# CITY OF ALBUQUERQUE

**RE: Oakland Heights Subdivision (File: C19D063)  
Grading and Drainage Plan, Engineer's Date 12-1-15**

<b>THE Group</b> 300 Branding Iron Rd. SE Rio Rancho, New Mexico 87124 Phone:(505)514-0995	
CITY OF ALBUQUERQUE PUBLIC WORKS DEPARTMENT ENGINEERING DEVELOPMENT GROUP OAKLAND HEIGHTS SUBDIVISION BEING A REPLAT OF LOT 12, BLOCK 3, UNIT 2, TRACT 2, NAA GRADING & DRAINAGE PLAN	
DESIGN REVIEW COMMITTEE	CITY ENGINEER APPROVAL
LAST DESIGN UPDATE	Mo./DAY/YR.
CITY PROJECT No.	ZONE MAP NO.
1009843	C-19-Z
SHEET	OF
1	1

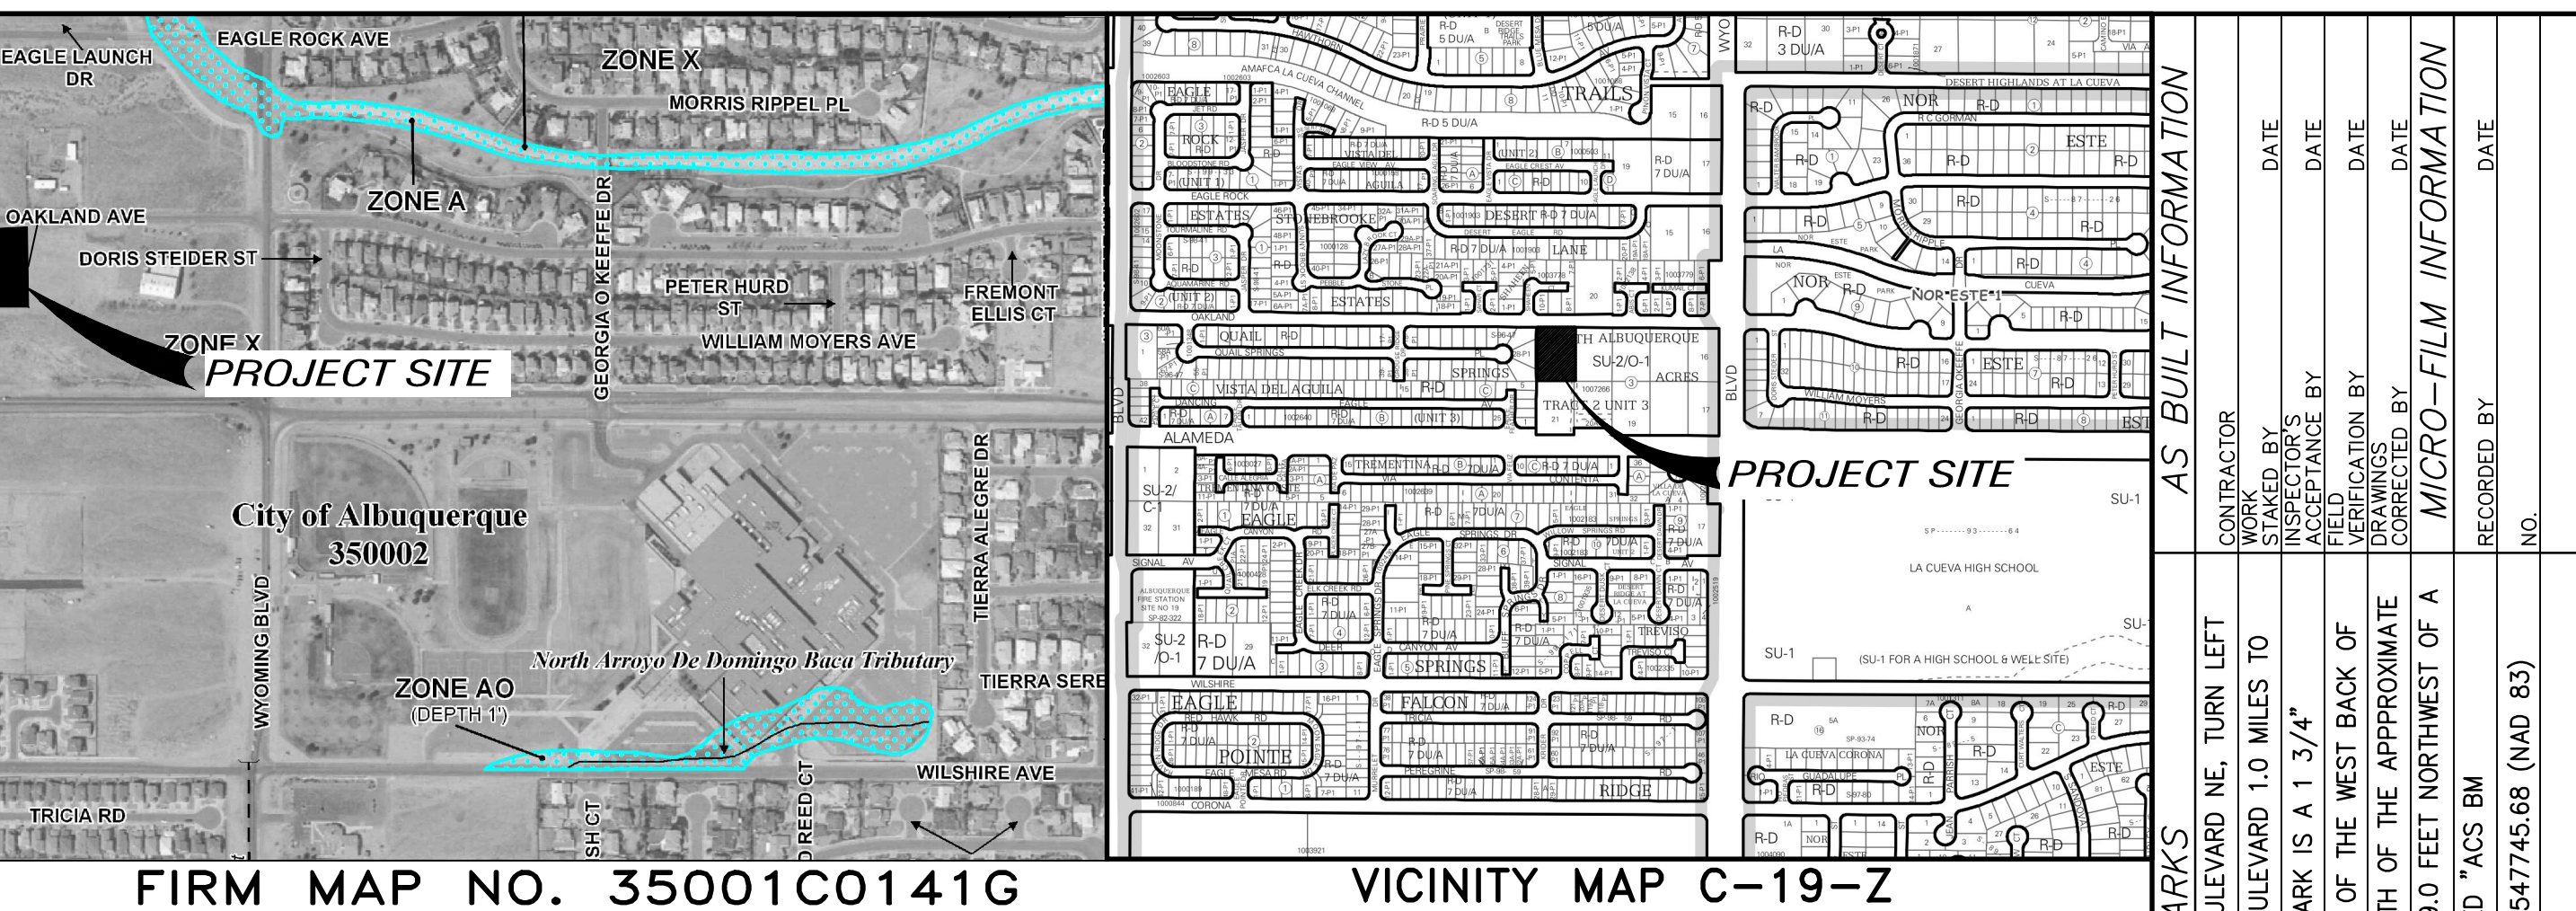
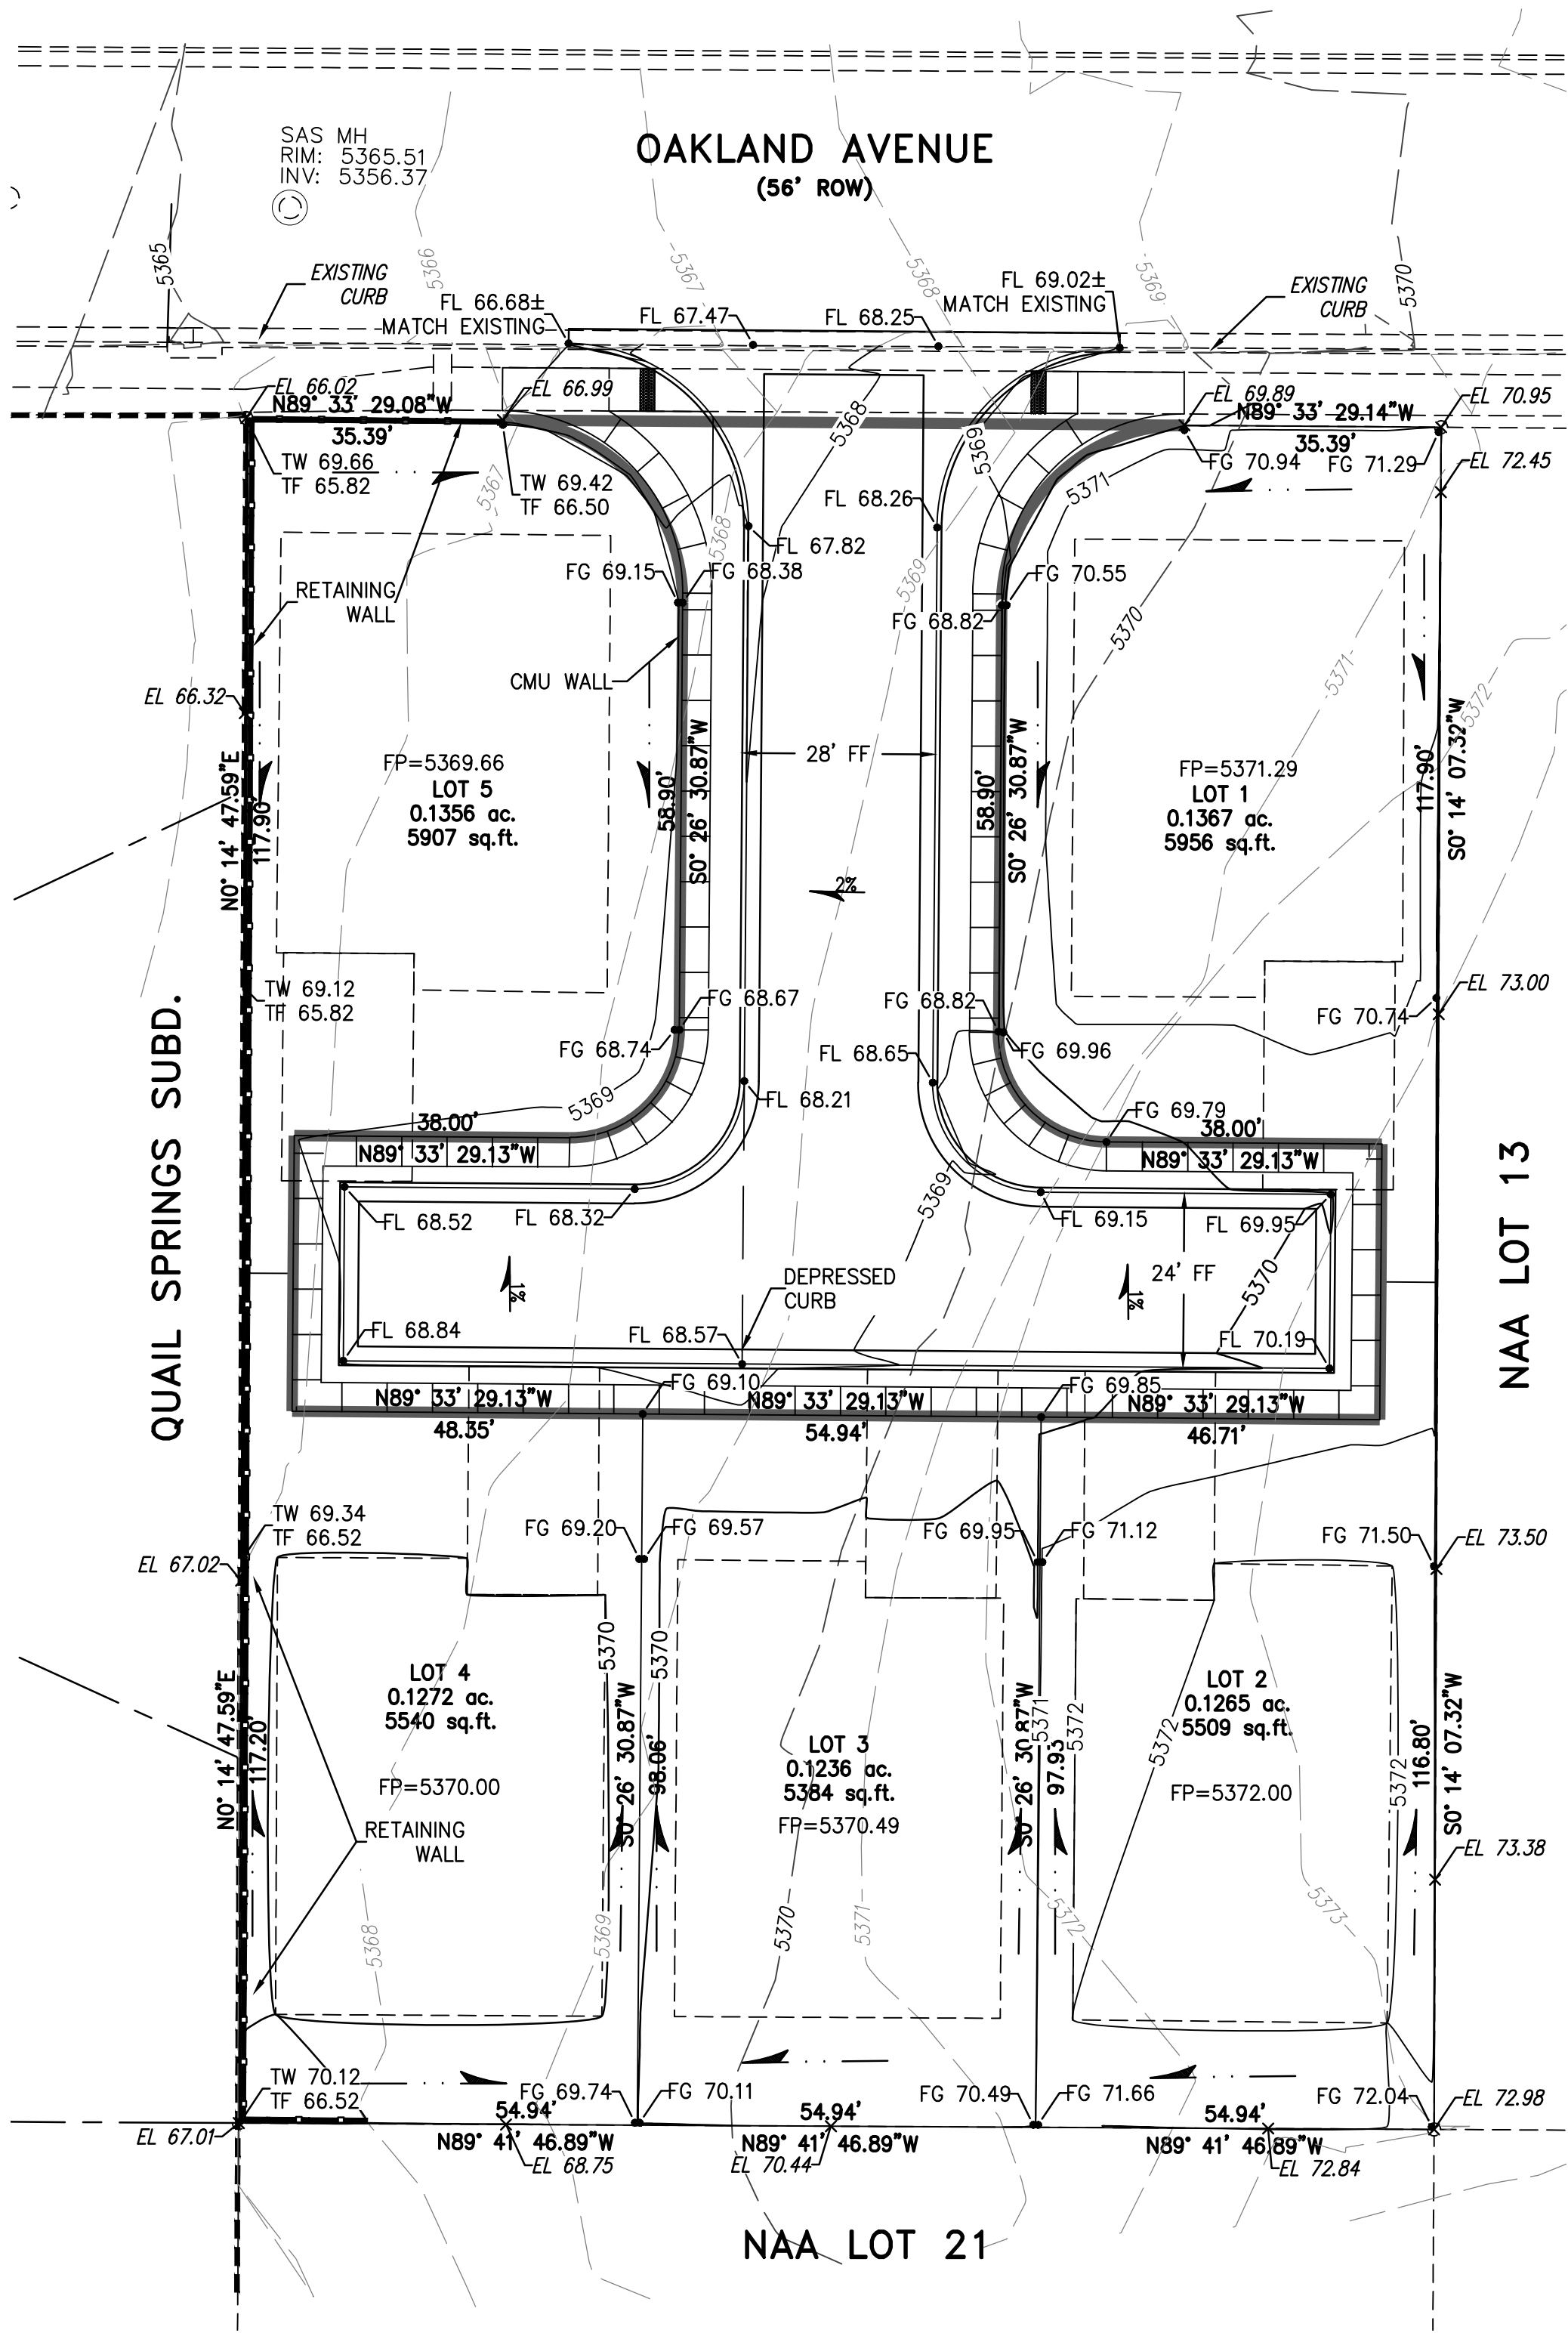
1. Looking at the NAAMDP Appendix, the Land treatments for this sub-basin are 25%B, 15% C, and 50% D (not 60% D as implied in the Land Treatment , Fig. 2A). Revise the Table to reflect these numbers, also state the Basin # that this site is in.
2. Provide existing contours or existing spot elevations for the site west of this development.
3. The East property line will have an existing retaining wall at the time of construction. Show the TW/BW elevations and indicate that it is a retaining wall currently under construction per drainage report C19D062.
4. Indicate in the Narrative why this site does not accept offsite flows.
